PCN# 20141212001 CC102x/CC1150 Orderable Part Number Retirement and Replacement

PCN Nun	nber:	2014	12120	01				PCN D	ate:	12/16/2014
Title: CC102x/CC1150 Orderable Part Number Retirement and Replacement										
Customer Contact:			PCN Manager Phone: +1(2			+1(21	4)480-6037 De		Dept:	Quality Service
Last date to order:			06/16/2015			Last date to ship:			-	09/16/2015
Change 1	Type:		Orderable Part Number Retirement					and Rep	lacemen	t

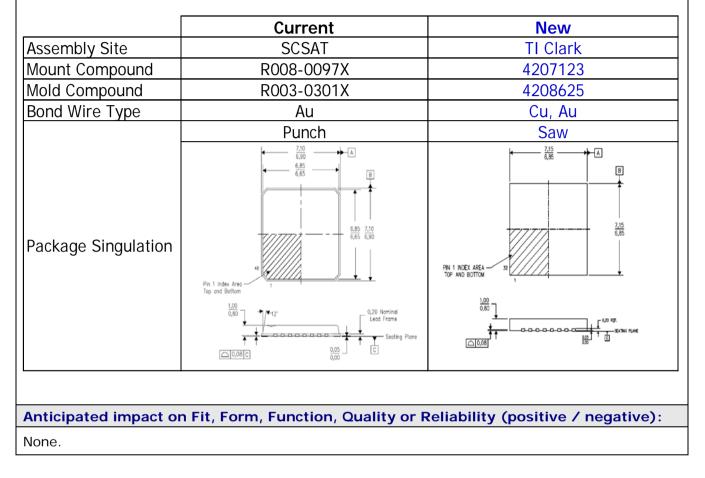
Note that the replacement product packages are sawn cingulated and are considered backwards compatible with the current punched packages, i.e. no PCB footprint change is necessary. Packing materials (shipping boxes, tape & reels, etc.) at the additional site will be consistent with materials currently in use at the current site.

Note also that the material sets of the replacement products are changing per the below:
